**SERRANO SUMMIT-CIVIC CENTER ADDENDUM  
TO ENVIRONMENTAL IMPACT REPORT**

*Program Environmental Impact Report  
(State Clearinghouse No. 2004071039)  
Addendum No. 2*

***Serrano Summit Area Plan 2009-01 and  
Tentative Tract Map no. 17331***

*Site Specific Environmental Impact Report  
(State Clearinghouse No. 2011501009)  
Addendum No. 1*

## See Table 10-1 Development Standards: SFD Rear Loaded

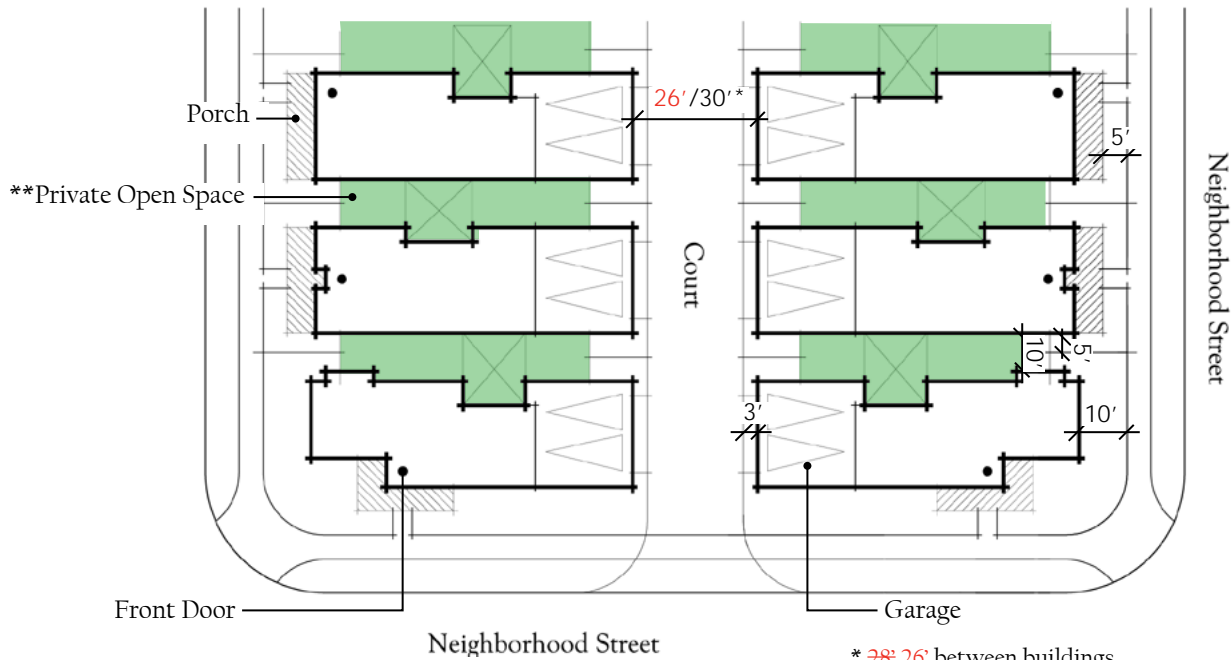
- Establish a setback of 26 feet between livable areas across an alley at the 2<sup>nd</sup> and 3<sup>rd</sup> stories for all three housing types.
  - Urban Court Building height of main structures – revise to 36 feet 6 inches.

\* 28' 26' between buildings  
30' between garage doors

See Table 10-2 Development Standards: **Urban Court**

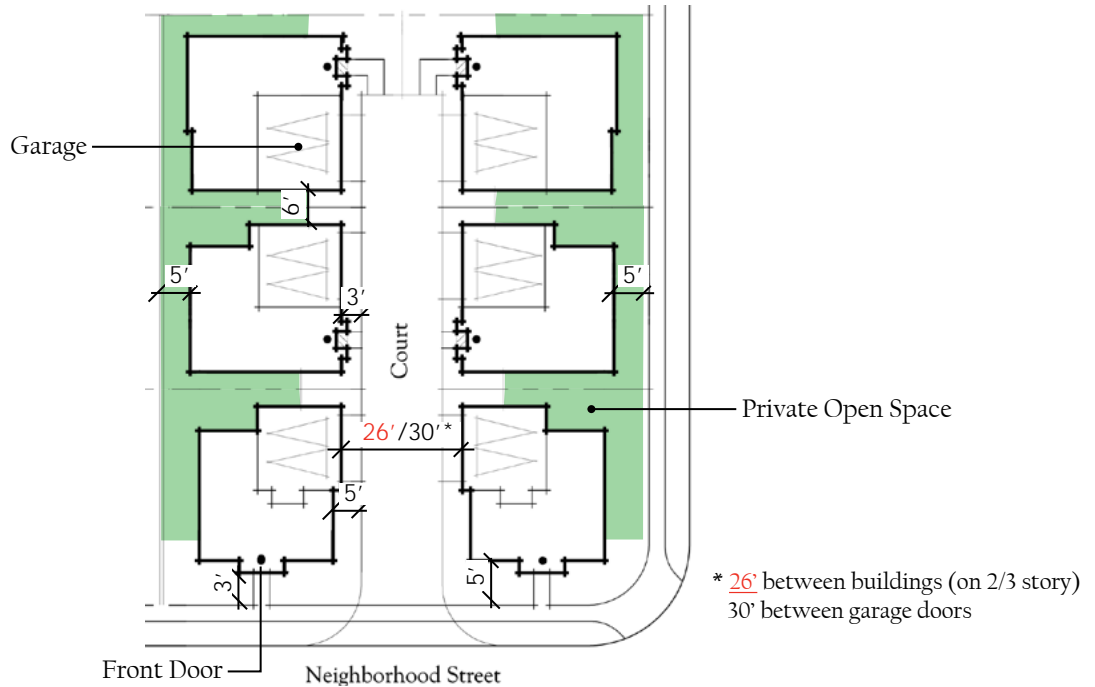
**NOTE: - “SFD Enclave” is not being removed but rather the designation is incorporated as a product type under the “Green Court / Motor Court” heading. New “Urban Court” proposed**

See Table 10-2 Development Standards: **Green Court**  
~~Rear Loaded Paseo Enclave~~  
~~Single Family Detached Enclave~~

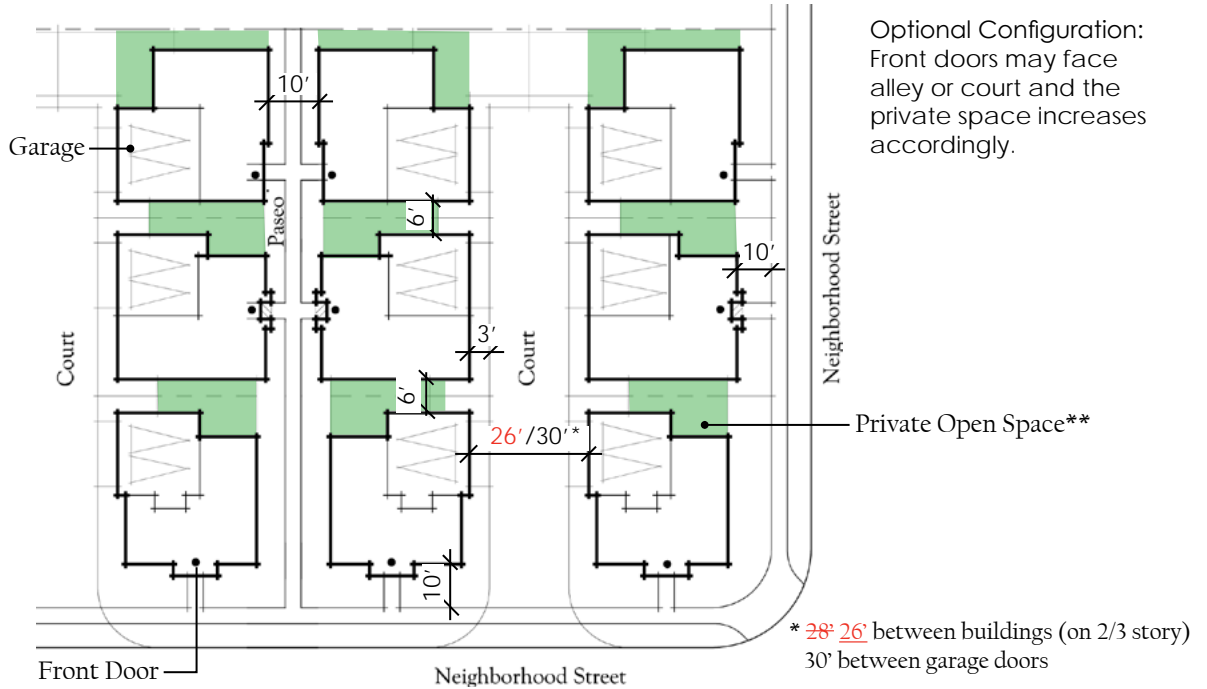
- 
- Add a new page of graphics and pictures to define the Urban Court housing type and update the graphics and pictures to better define the Green Court, Motor Court, and Rear Loaded Duplex housing types to reflect the revisions to the development standards.

### See Table 10-3 Development Standards: Rear Loaded Stacked Flats (with Carriage Units)

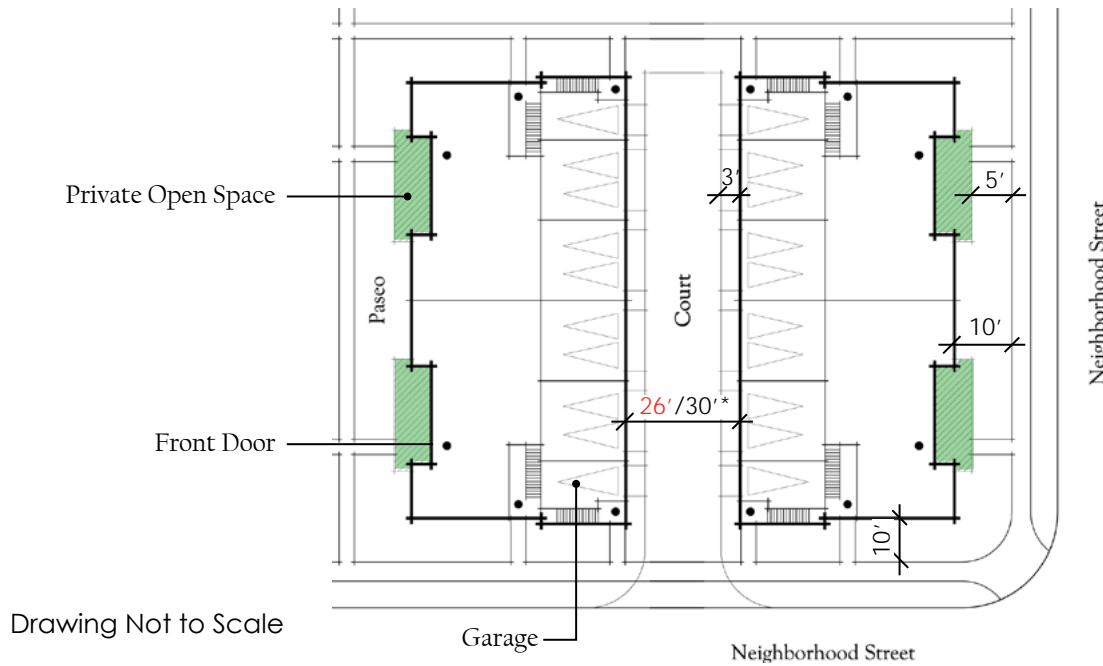
- Revise Table 10-3 and update the corresponding graphics to establish a setback of 26 feet between livable areas across an alley at the 2<sup>nd</sup> and 3<sup>rd</sup> stories for the Townhomes/Triplexes, Rear-Loaded Stacked Flats, and Front-Loaded Stacked Flats housing types.

\* ~~28'~~ 26' between buildings (on 2/3 story)  
30' between garage doors

**Tentative Tract Map  
No. 17331 Comparison**

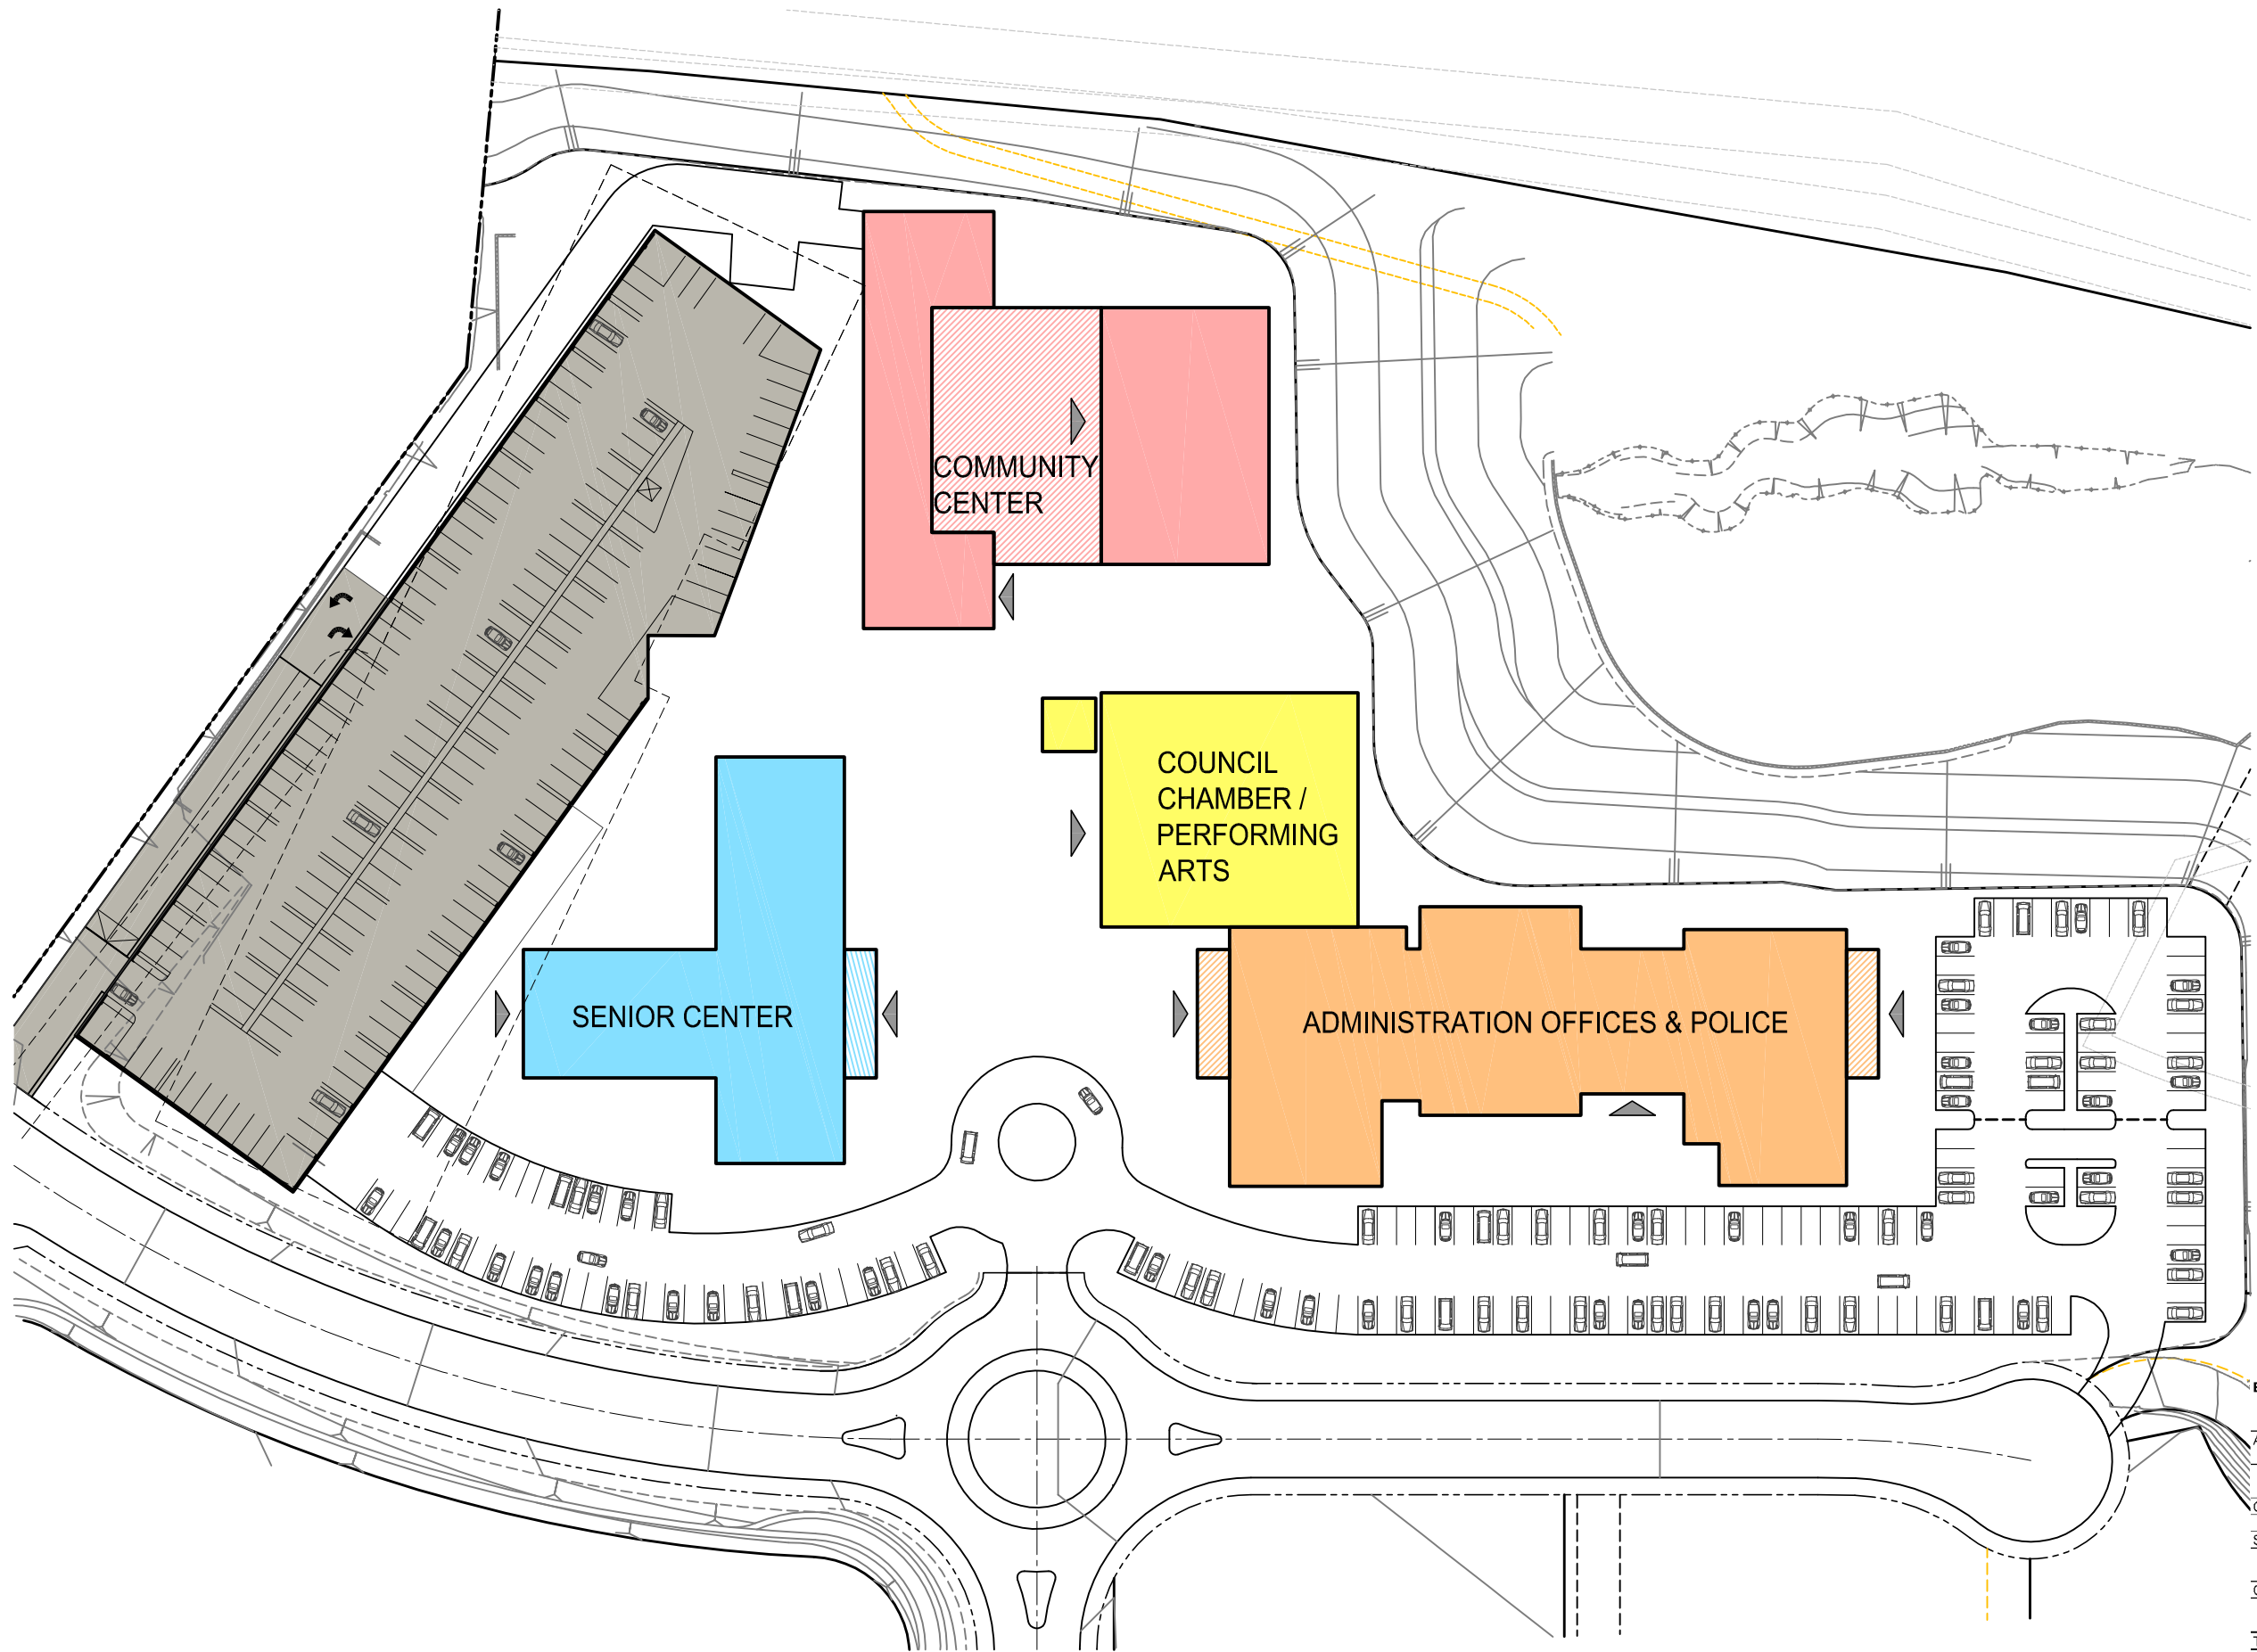
- Reduce the size of the Civic Center pad from 9.3 acres to 8.13 acres.
- Reduce the Residential area by 0.67 acre.
- Reduce impacts on the Civic Center site to avoid impacts to biological resources and jurisdictional waters of the U.S. and State.
- Maintain a balanced earthwork. The original plan included 916,000 cubic yards of cut and 916,000 cubic yards of fill, not including remedial grading. The revised plan has the same amount of cut; however, the fill area has become smaller to account for avoiding biological resources. In order to keep the site balanced, the excess dirt will be used to raise pad elevations approximately 2 to 3 feet above original approval.
